CHECK PRINT 1/9/04

rev 11/18/02 rhm/ GTP			
title Digital Optical Module Crystal			
Size	Document Number	sheet 3 of 14	Rev 12.0
Date: Wednesday, October 09, 2002 sheet 14 of 14

rev 11/19/02	rhm/glp	rev 12/11/02	rhm	repaired	gnd	symbol
Title Digital Optical Module Power Supply						
Size	Document Number					Rev
C	main_board_vsn4.1					sheet 4
Date: Wednesday, October 09, 2002	Sheet 13					of 14

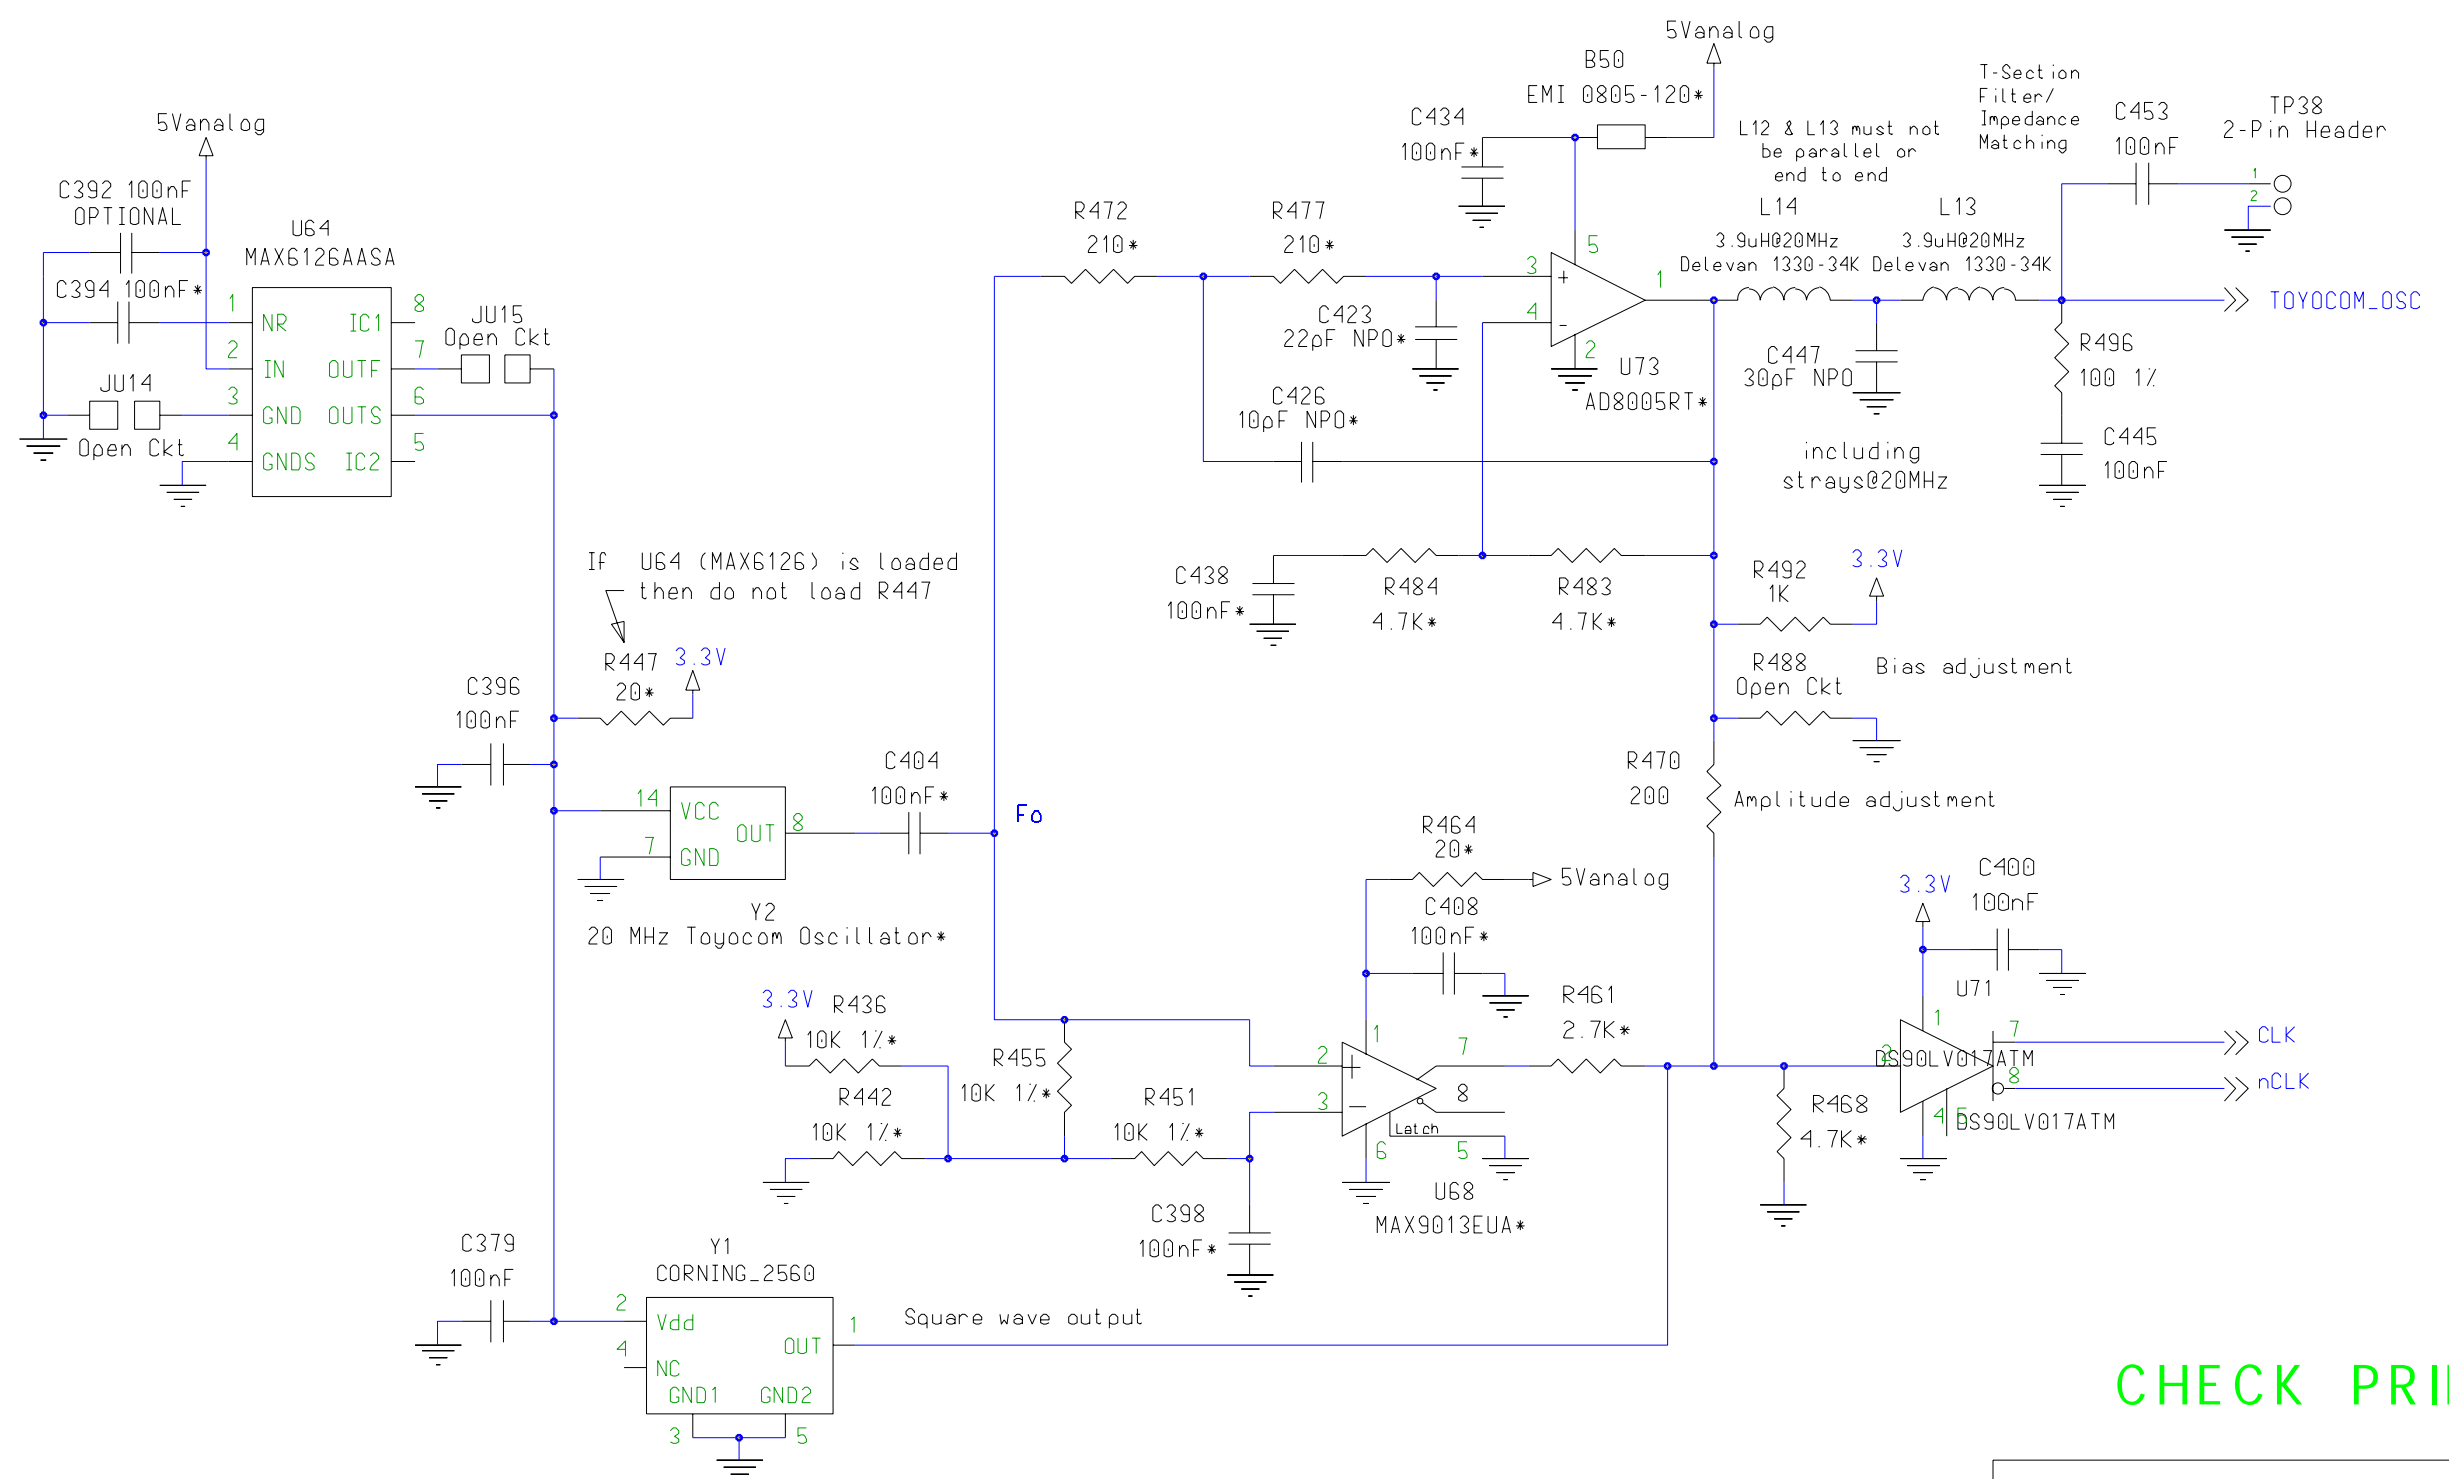
If inductors L12 & L13 shift as the temp. decreases, it is possible to compensate by giving the capacitor the correct temp. coefficient.

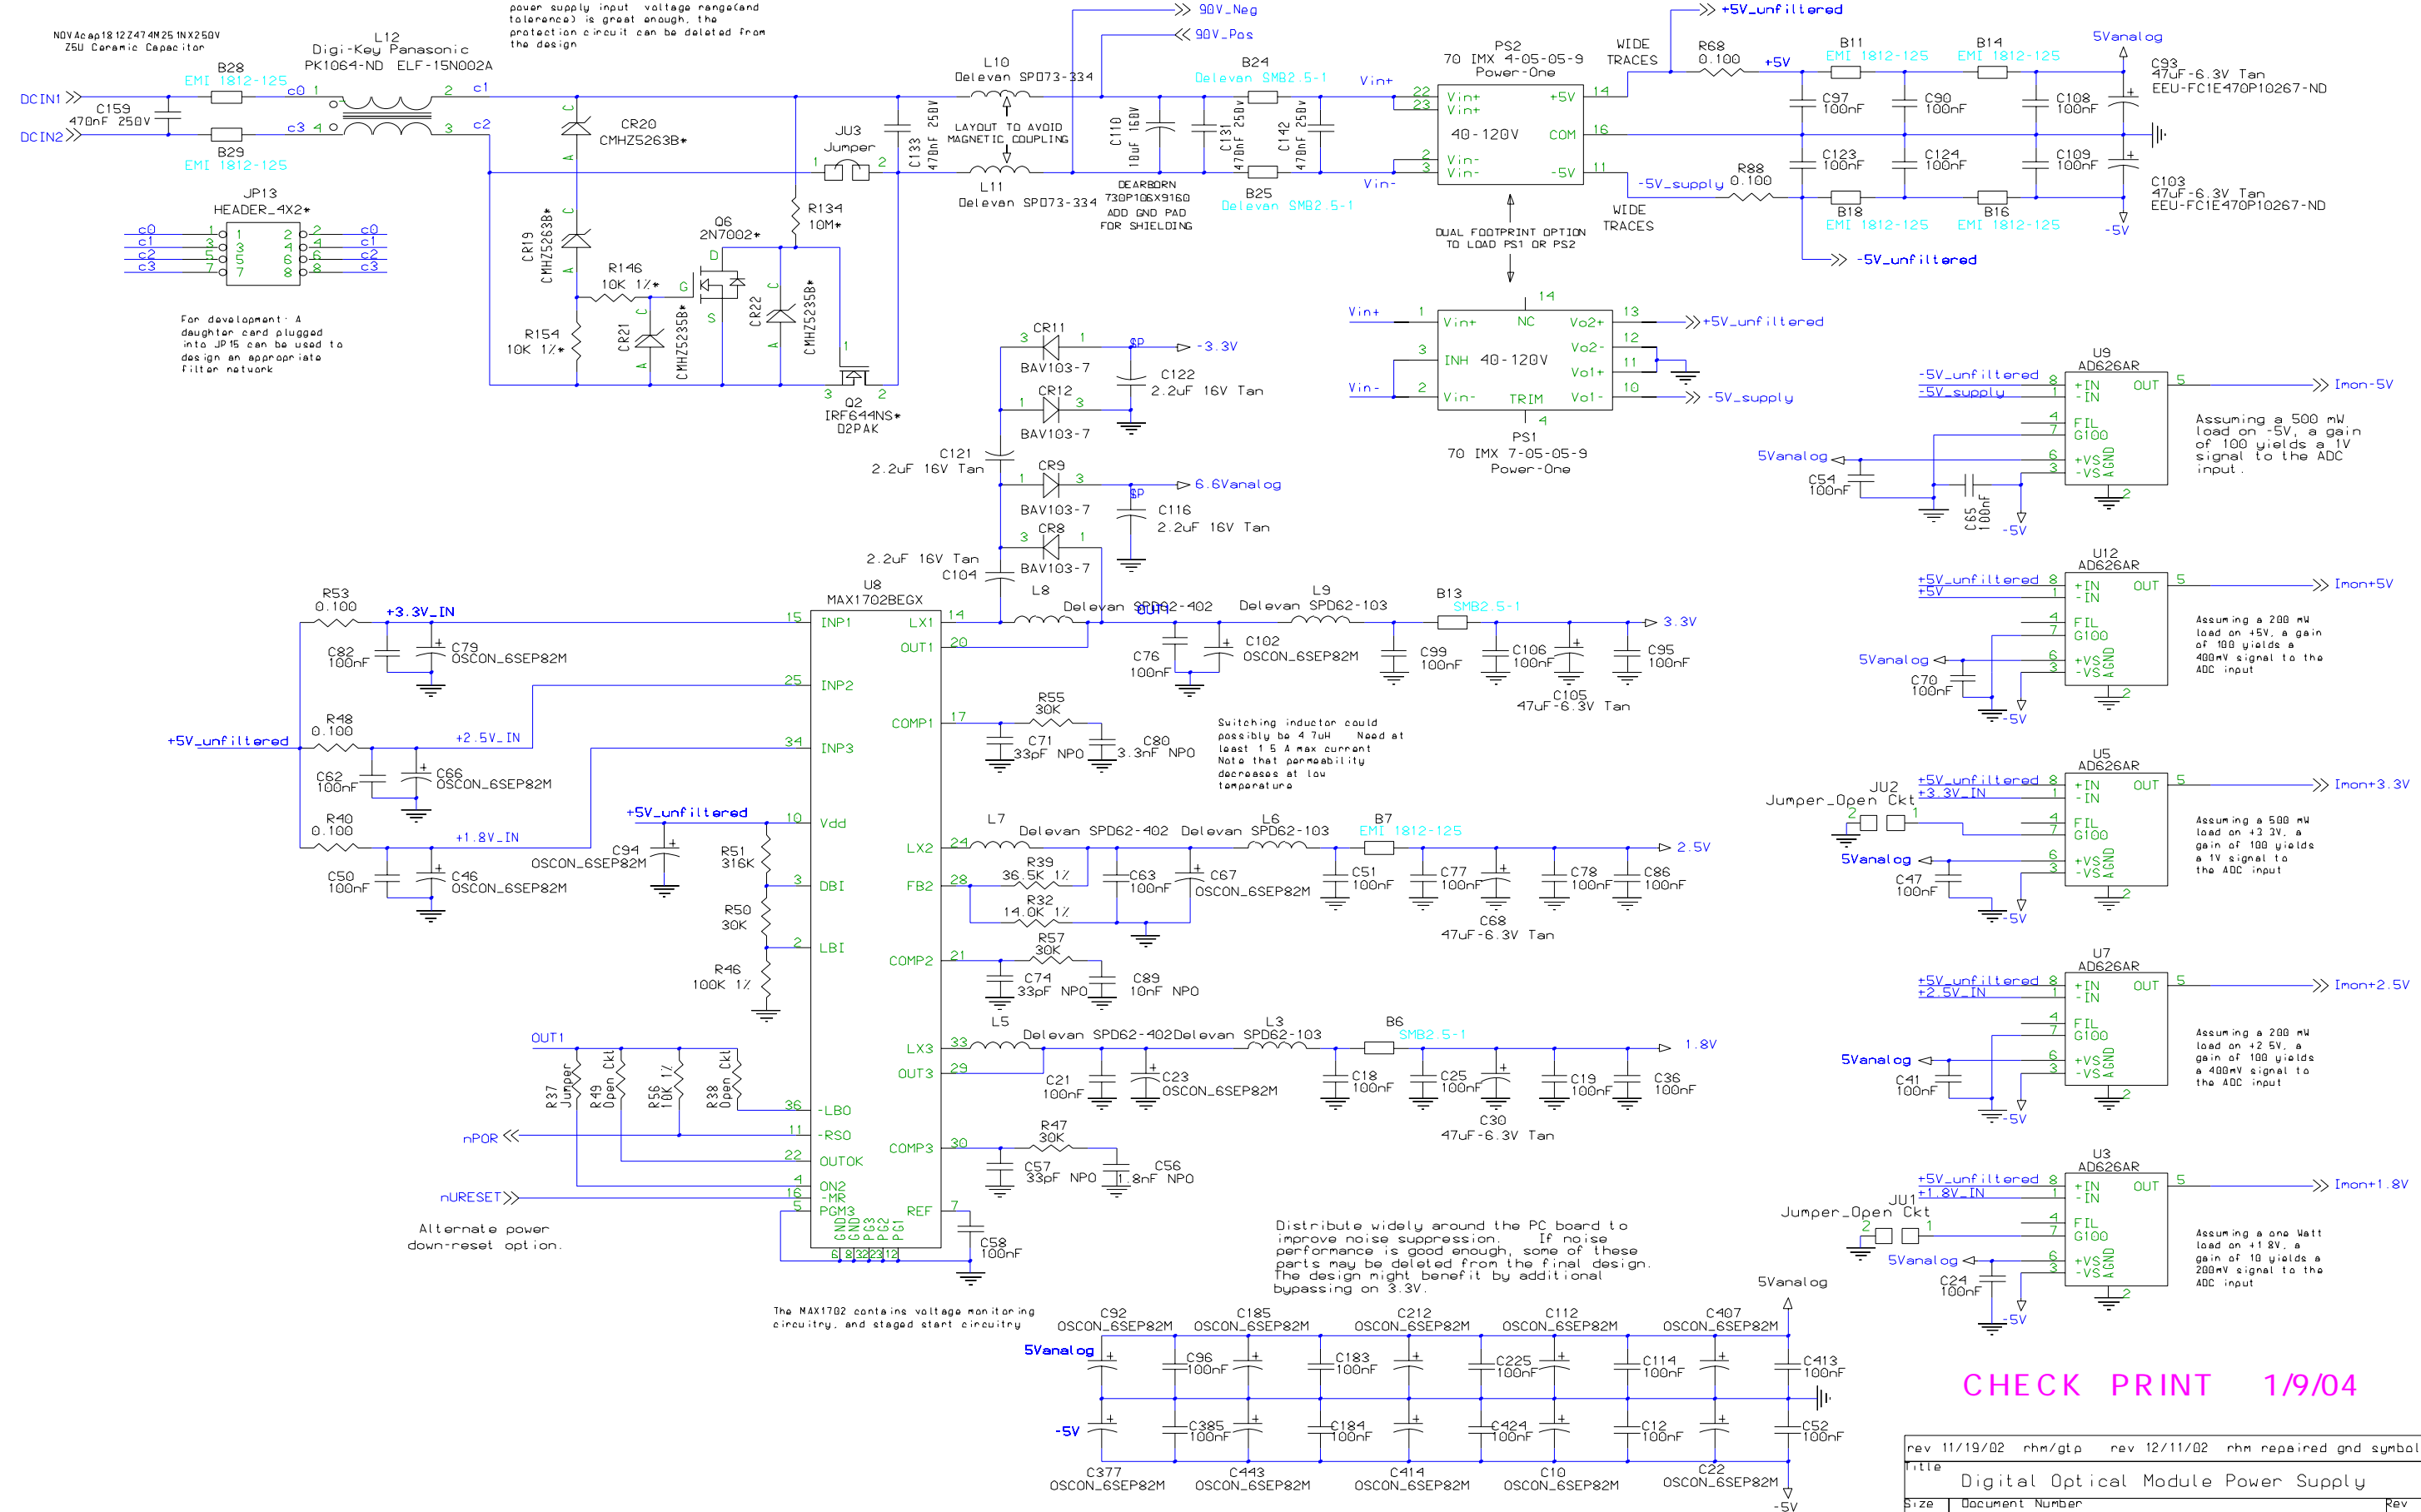
Over-Voltage protection for the power supply. I suppose, this could as easily be balanced, using just the N and P FETs. If it is deemed that the power supply input voltage range (and tolerance) is great enough, the protection circuit can be deleted from the design.

For development: A daughter card plugged into JP15 can be used to design an appropriate filter network.

Switching inductor could possibly be 4.7uH. Need at least 1.5 A max current. Note that permeability decreases at low temperature.

Distribute widely around the PC board to improve noise suppression. If noise performance is good enough, some of these parts may be deleted from the final design. The design might benefit by additional bypassing on 3.3V.

File	Digital Optical Module CPU	Rev
Size	Document Number	12.0
D	me n_board_vsn.4.1 sheet 6	
Date	Wednesday, October 09, 2002 11:02	14

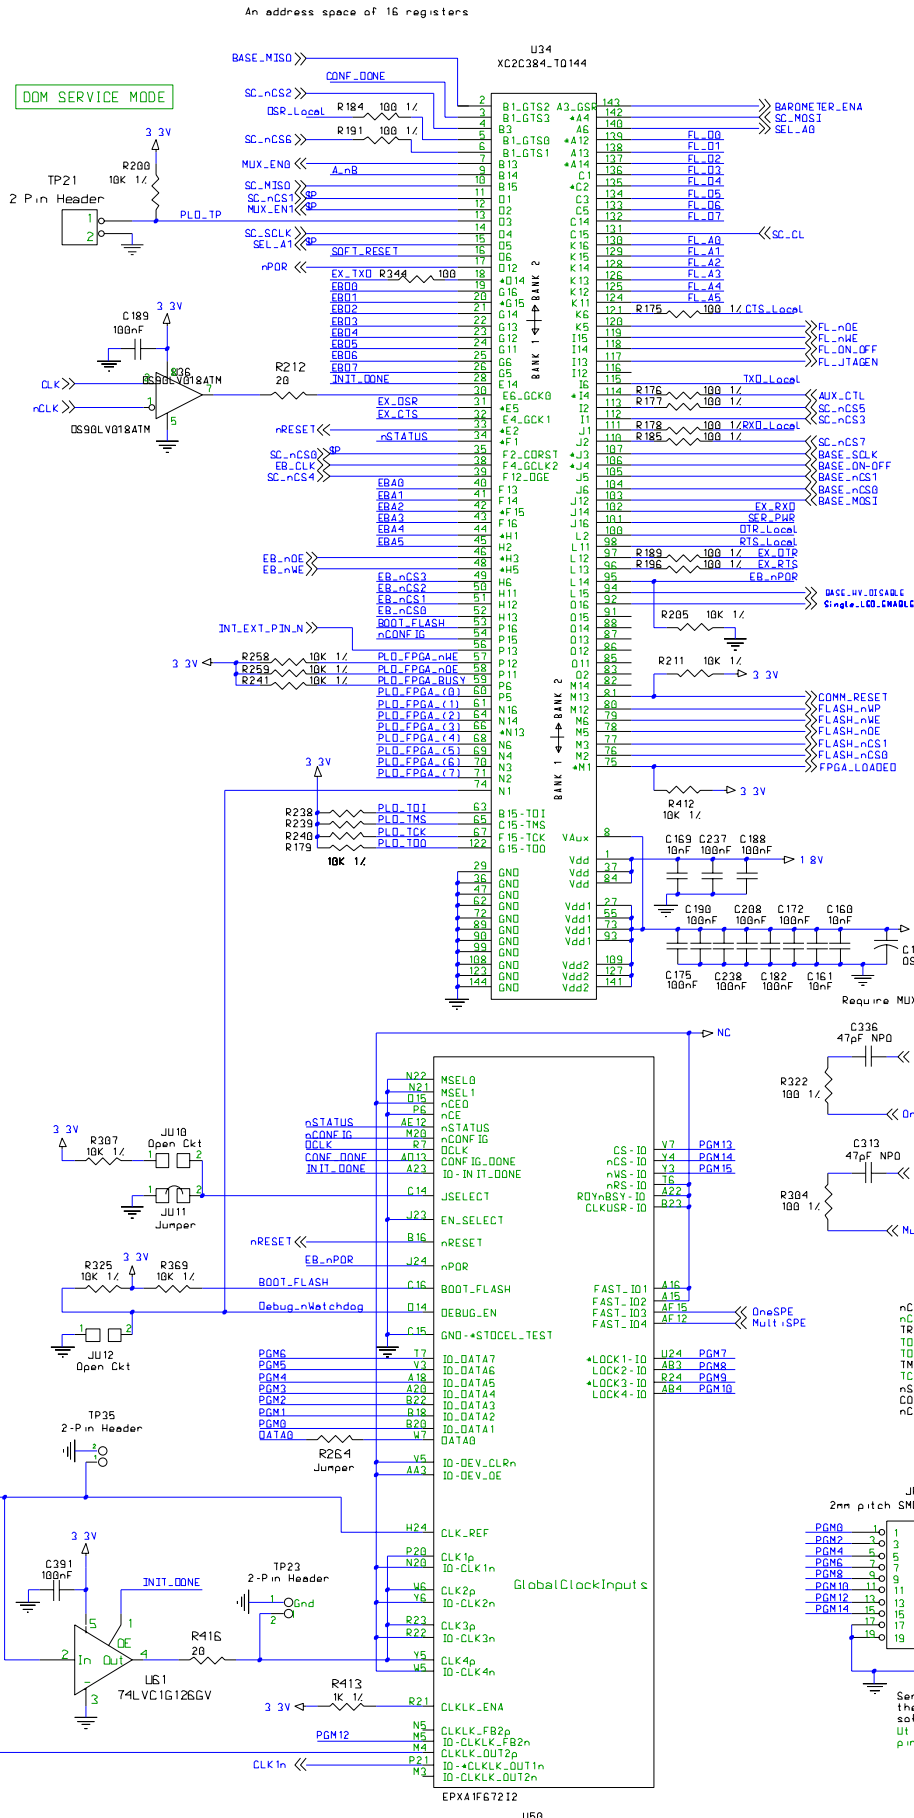
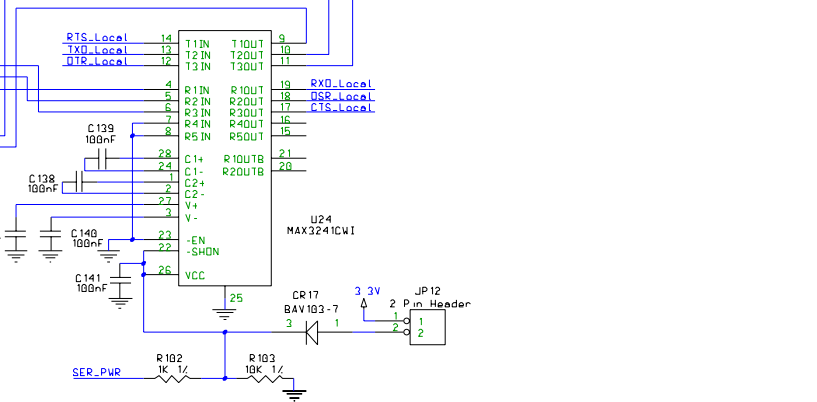
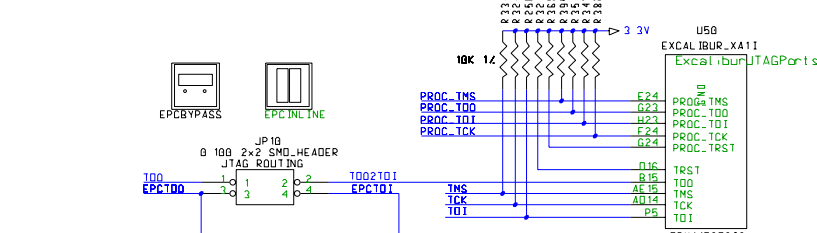
Require MUX\_ENA low at power up  
 Require HV power supply control  
 at power up, and through  
 reloading the FPGA  
 BOOT\_FLASH line control

Desire:  
 ADC and DAC control not  
 depending on FPGA load (avoid  
 glitches)  
 Remember source of power failure  
 Flash Memory CSR remapping
